**DEPARTMENT OF HOUSING AND
URBAN DEVELOPMENT**

**Model Manufactured Home Installation
Standards**

ACTION: Final rule.

SUMMARY: This final rule establishes new Model Manufactured Home Installation Standards (Model Installation Standards) for the installation of new manufactured homes and includes standards for the completion of certain aspects necessary to join all sections of multi-section homes. The National Manufactured Housing Construction and Safety Standards Act of 1974 requires HUD to develop and establish Model Installation Standards after receiving proposed installation standards from the Manufactured Housing Consensus Committee (MHCC). HUD received and reviewed the MHCC's recommended proposed model installation standards and published a proposed rule for public comment. Based on HUD's review of the comments that were submitted, including those from the MHCC, a number of revisions to the proposed rule have been made in this final rule. This final rule also incorporates certain amendments to definitions contained in the Manufactured Home Construction and Safety Standards (MHCSS) that are affected by definitions provided in the Model Installation Standards.

Figure to § 3285.203 - Grading and drainage.

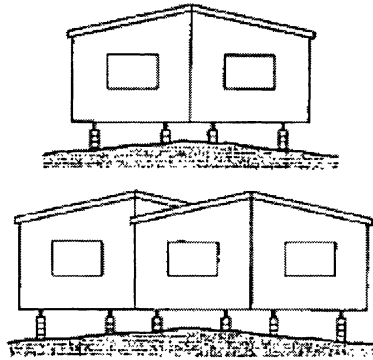
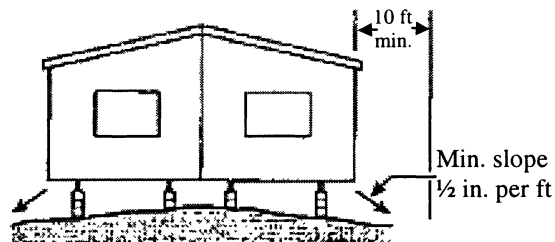
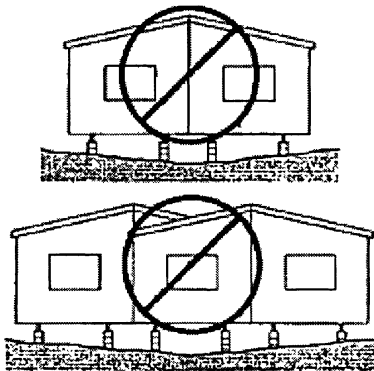
Comment: § 3285.203(a) Drainage. The section should be revised to read as follows: "Drainage must be provided to direct surface water away from the home." This was suggested because the commenter believed it unnecessary to include a "laundry list" of possible problems, if proper drainage was not provided, that was identified in the proposed rule.

Comment: As written, subsection (b) would be impossible to enforce within rental communities given their layout and design. The requirement should be revised to provide an exemption for homes sited within manufactured home rental communities, or by changing the drainage requirement "from under" to "away from" the home. Further, in subsection (c) the first 10-foot provision would be impossible to enforce in rental communities, since lots only provide for 5-foot sideyards and that the requirement should be revised to require drainage away from the foundation of the home for the first 5 feet.

Comment: § 3285.203(f) Gutters and Downspouts. Most home manufacturers

do not provide additional support in the roof system in order to support gutters and downspouts. Installation could cause damage and take the home out of compliance with the MHCSS. However, if gutters and downspouts are provided, the runoff must be directed away from the manufactured home.

Comment: Even though the Model Installation Standards require any runoff from gutters and downspouts to be diverted away from the home, not all HUD Code homes are required to have gutters and downspouts. If gutters and downspouts are provided, then installers should be required to ensure that adequate drainage is provided.

HUD Response: The final rule has been revised to clarify that surface water must be directed away from the home to prevent water build-up under the home. Where property lines do not allow the drainage to be diverted for the first 10 feet from the foundation, other methods are allowed to remove the surface water. However, statements on the adverse affects of not removing the water have been removed from this section, as suggested by commenters.

HUD Response: The final rule has been revised to require manufacturers to specify in their installation instructions whether the manufactured home is suitable for the installation of gutters and downspouts and if so provided, the instructions are also to indicate that all roof water is to be directed away from the home.
